Mask Set Errata 4

M68HC912D60 Microcontroller Unit

This mask-set errata provides information pertaining to the following 68HC912D60 MCU mask set devices:

- 4F73K, available from January 1999.

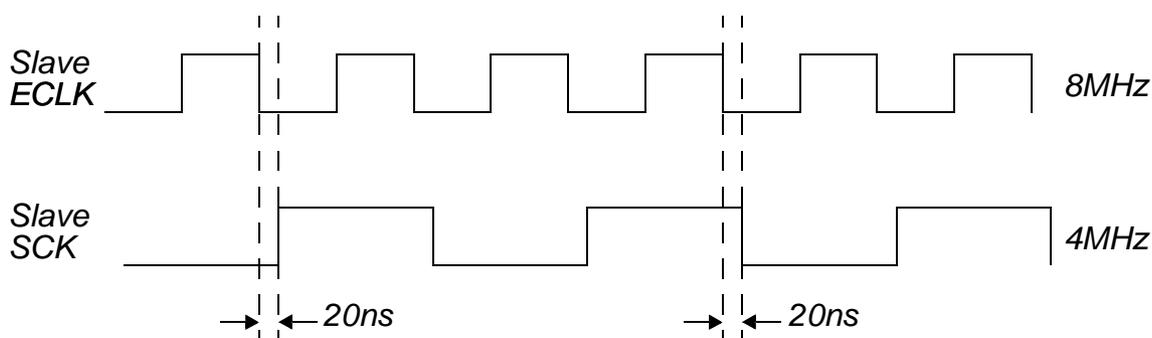
SPI: SPIF FLAG IS NOT SET WHEN OPERATING IN SLAVE MODE AR568

If the SPI on the HC912D60 is operated in slave mode, the SPIF flag is occasionally not set when valid data is received. The failing condition only occurs if the slave node's ECLK signals falling edge leads the SPI's incoming SCK signal by a specific phase difference.

NOTE: *The failure is very rare and has only been witnessed when the slaves ECLK falling edge leads the SCK by (20nS \pm 4nS). The failure never occurs if the SPI is operated as the master. The diagram below shows an example of the timing relationship when the failure occurs.*

1. Only use the SPI in slave mode if there is a fixed clock phase relationship between the master and slave clocks, avoiding the above scenario.

2. Implement a software timeout to gate reception of data. May require use of additional I/O for handshaking.

Figure 1. Representation of Normal start-up condition

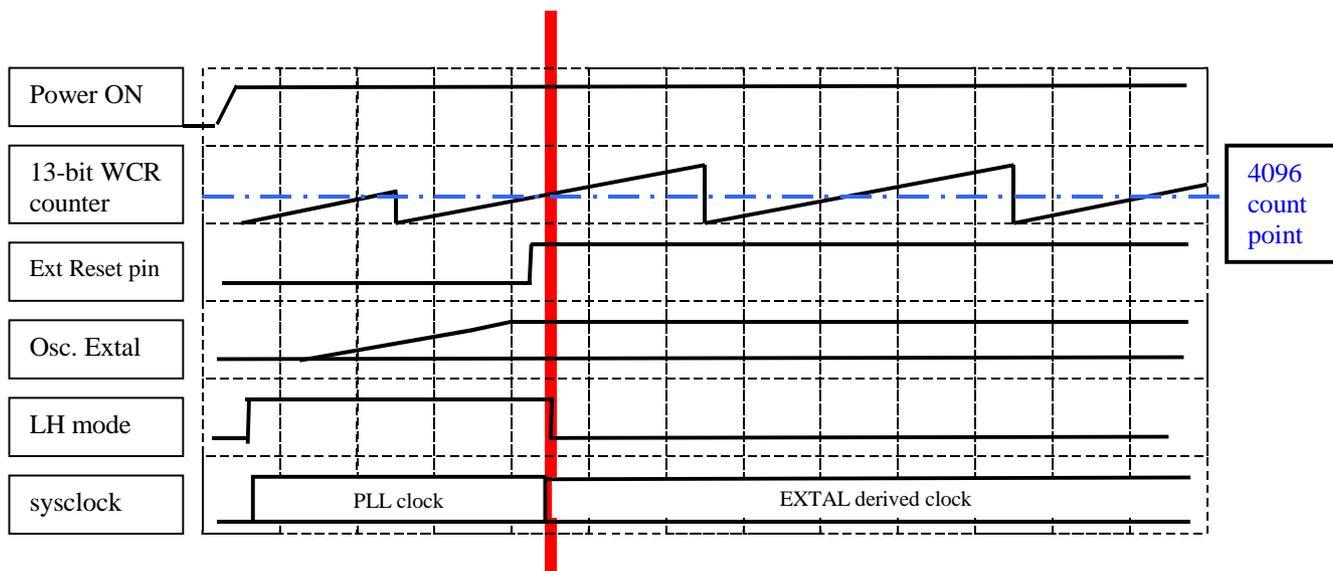
Common practice for the start up mode of operation of HC12 microcontrollers is for the external RESET line to be held active until such time as the crystal has stabilized at its operating frequency. On release of the external RESET line and when the WCR (counter register) reaches a count of 4096 cycles, normal operating mode is entered with the CPU clocked from the crystal frequency (see fig. 1).

Figure 2. Representation of unreliable start-up mode with slow crystal

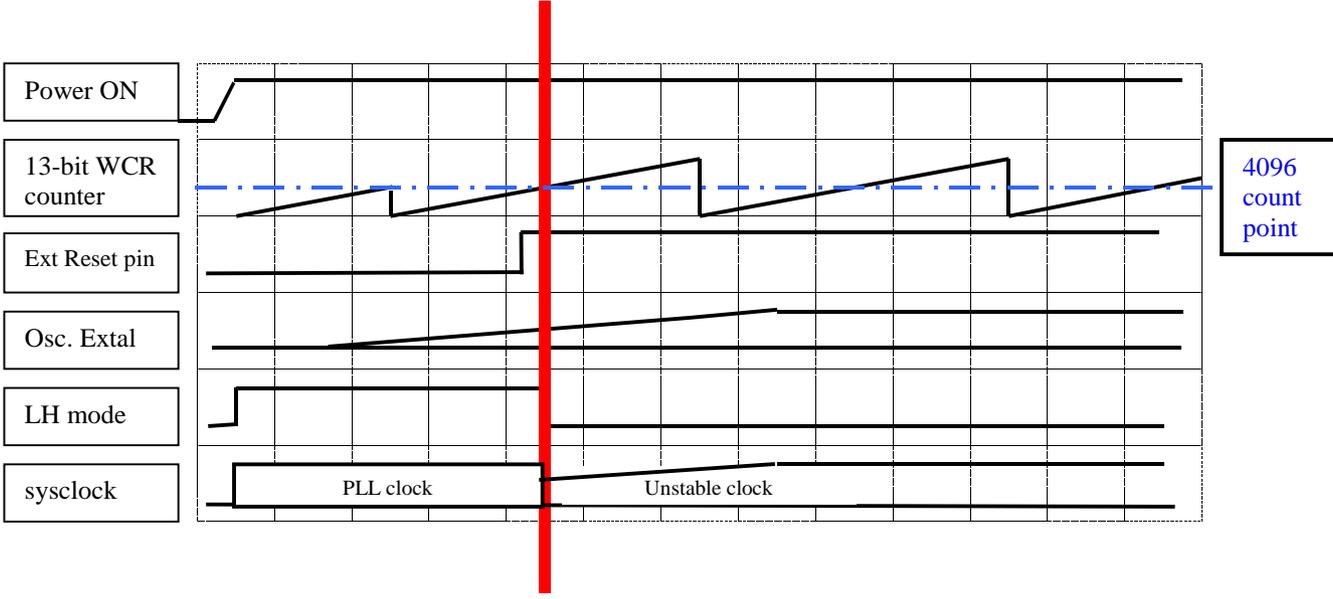
The device can prematurely indicate that the oscillator has stabilized releasing the part from Limp Home clock mode to the oscillator clock mode with an unstable oscillator. This can cause unpredictable behavior of the MCU. This situation can arise with short external power-on reset periods and / or crystal oscillator circuits that exhibit slow startup characteristics. If the PLL is not being used (Vddpll connected to Vss) Limp Home mode is disabled and this issue does not apply.

The HC12 mode of operation known as Limp-Home Mode (LHM) is enabled when the VDDPLL pin is at VDD and is entered if for any reason the external crystal ceases to oscillate. During this mode the CPU will be clocked from the free-running VCO clock of the PLL (at a nominal frequency of 1MHz). If LHM is enabled during the start-up phase (i.e. VDDPLL=5V, NOLHM bit=0) and the external RESET line is not held active until after the crystal frequency is stable then the device starts up

in LHM since no crystal oscillations will be detected. This situation can arise with short reset periods and/or crystals that exhibit slow start-up characteristics.

For the first 4096 cycles i.e. during the internal reset period, Limp Home mode will be de-asserted if oscillator activity is detected by the clock monitor circuit -due to the asserted Reset signal there can be no CPU activity during the Reset phase. Following release of the external or internal POR RESET in LHM (which ever is later) the crystal oscillator is sampled by the clock monitor circuit after another 4096 VCO clock cycles and at intervals of 8192 clock cycles thereafter until the crystal is deemed to be operating. If the crystal oscillator is showing activity at the time it is checked then it will be deemed to be good, even though it may not have fully stabilized, and LHM will be de-asserted. This can cause the device to switch from LH mode to normal mode with the CPU clocked from an unstable signal from the crystal oscillator (see fig. 2) resulting in unpredictable function of the CPU.

Figure 3. Representation of preferred means of overcoming issue with Figure 2

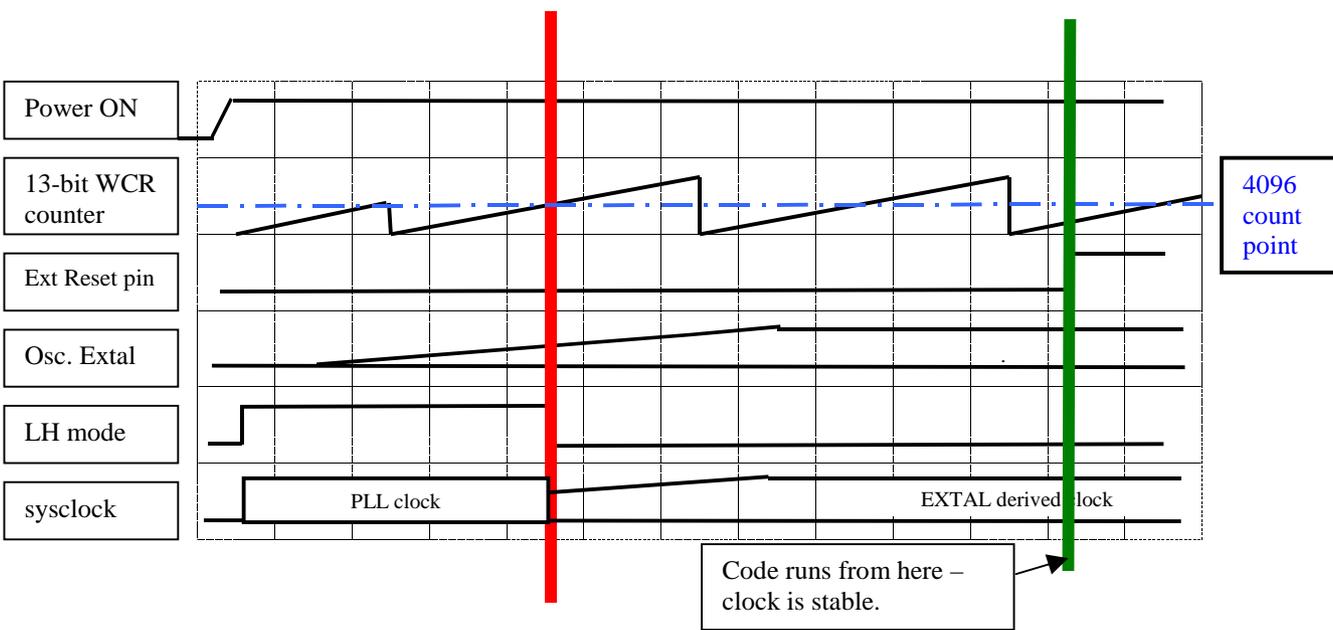
The Reset condition can be overcome by allowing the crystal oscillator circuit to stabilize before releasing the external RESET line (see fig. 3). Operation is similar to that shown in fig 2.

To determine if crystal is 'stable' at the release of reset can be difficult and the time can vary some from board to board. If the customer has special high impedance probes, it is possible to monitor the amplitude of the voltage from XTAL to ground (<2 pF scope probes are recommended). Please note that any loading on the circuit can affect its operation. (Any resistance to ground or Vdd on the EXTAL pin can greatly attenuate the amplifier gain and cause erroneous operation.)

A second way to measure the oscillator startup time is to monitor the XFC pin. This method does not require a high impedance scope probe. The PLL will not lock until the oscillator clock feeding it is present and stable. Remove the external reset circuit and during power up watch the XFC pin. The voltage should start high (Vdd). After the part releases internal reset it will drop to some stable voltage between Vdd and Vss. If external reset (measured independent from this test) is held till this 'stable voltage' time the oscillator will be stable. Please note the filter components mounted on the XFC pin will affect this ramp (for evaluation purposes, alternative components can be selected to provide a fast lock time). More than one board should be measured because of pcb and crystal variability. It is also recommended that the test be run over the operating temperature of the device.

Lastly, an alternative and simpler approach is to just hold reset low for a substantial time (> 100 milliseconds) after Vdd has reached the operating voltage range.
